Proposed advertising sign on north-western corner of Pacific Highway/ Government Road intersection, Hornsby

Peer review of Safety Assessment Report

DPIE-PROJ-0006-03 PEER REVIEW OF Hornsby Rev 1

17/2/2024

Figure 2-7: Crash Location in Recent 5-Year Period

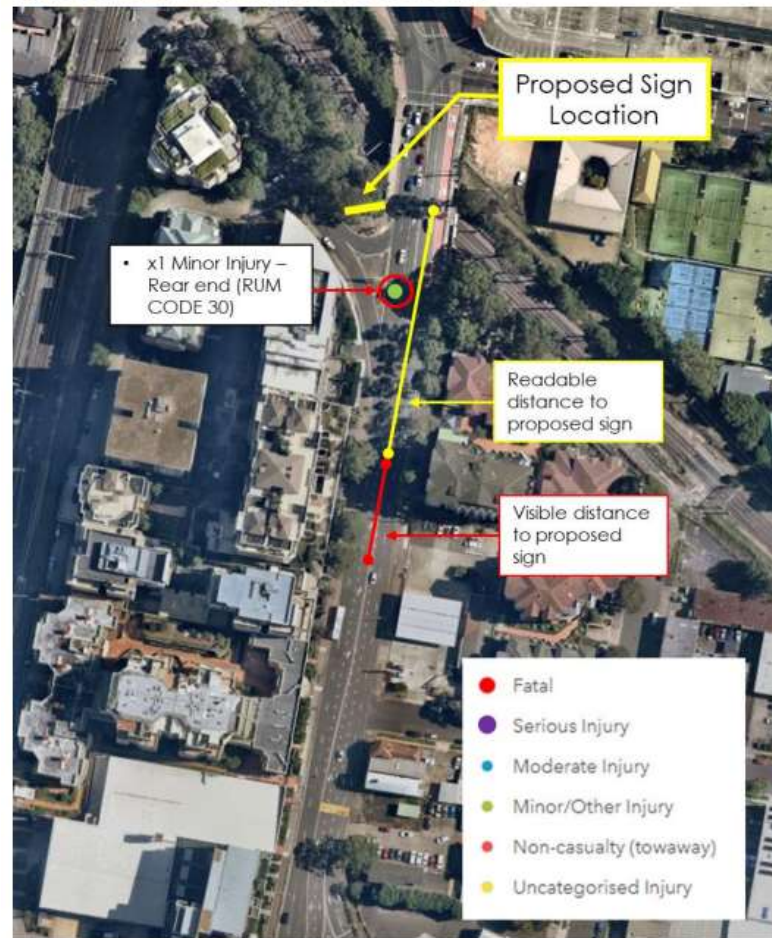
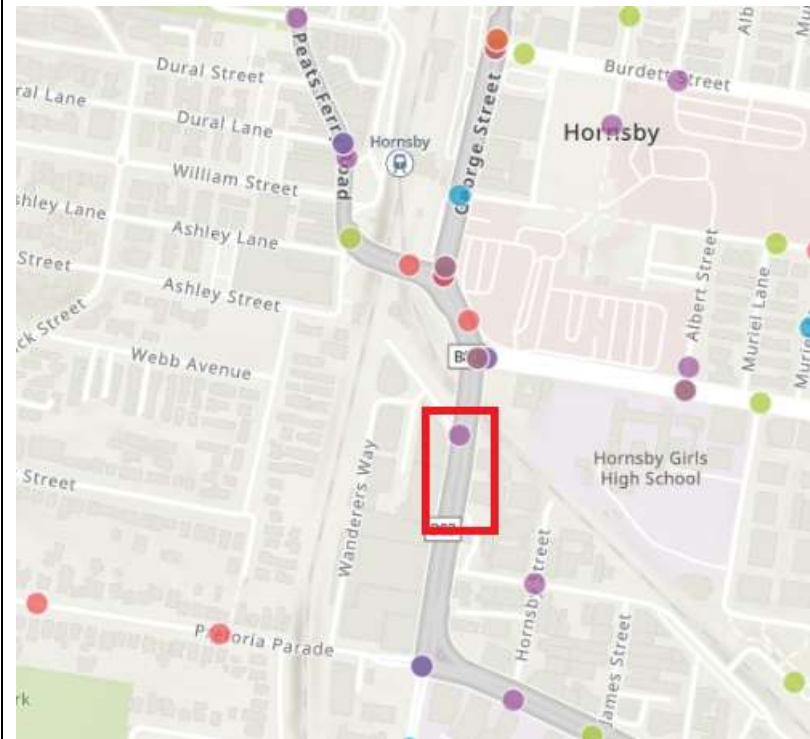
Further to the second bullet point above, the apparent low-frequency of crashes was largely due to the limited spatial coverage of the crash study, being a 95m length of road upstream of the proposed sign. This study length is boxed in red below. However, as shown by the numerous other dots (crash events), a wider spatial coverage indicates a propensity for crashes across the wider network. If a more macroscopic view was taken, and an appreciation that crashes in the wider network could have just as easily happened at the subject location, a much different narrative would be created, ie. that the subject site is in fact a moderate to high risk site to begin with.

Extract from the Transport for NSW interactive crash map, showing crashes in the wider network for the five year dataset period from 2018 to 2022.

Figure 3-1: Pedestrian Desire Lines Near the Proposed Digital Sign

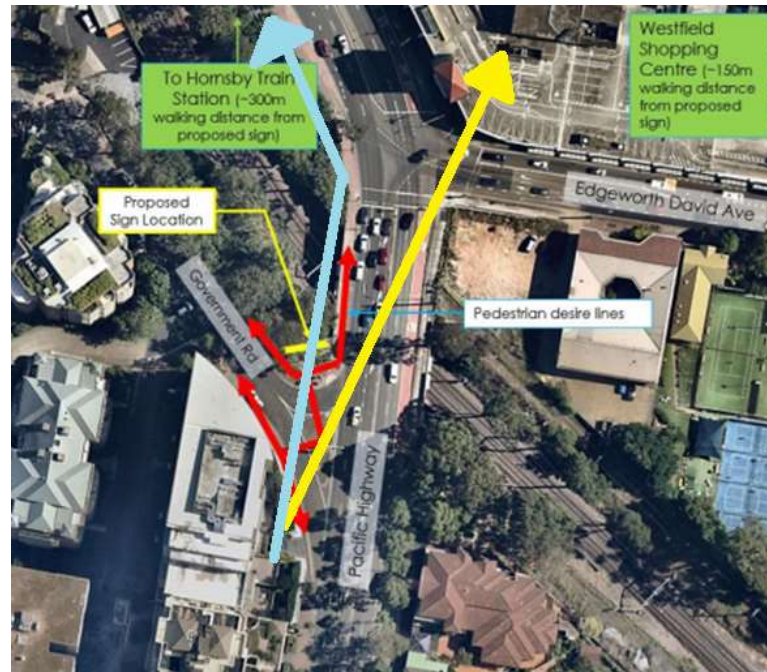
The desire lines depicted in Figure 3-1 largely assume that all pedestrians will comply and be sensible. The true desire lines are based on the relative attractiveness of end destinations, and how much “gravity” each individual destination has. The major attractors and generators in the local area would be the local schools, the train station and the shopping centre. Using the shopping centre and the train station as selected examples, the desire lines are more likely to be represented by the yellow and blue arrows. These desire lines are based on the “pull direction” of each attractor/ generator. Pedestrians/ walking is the most fluid and unrestricted transport mode and assuming no mobility and visibility constraints, and traffic conditions that can accommodate, many pedestrians will use the shortest route available, even if it is a non-conforming route.
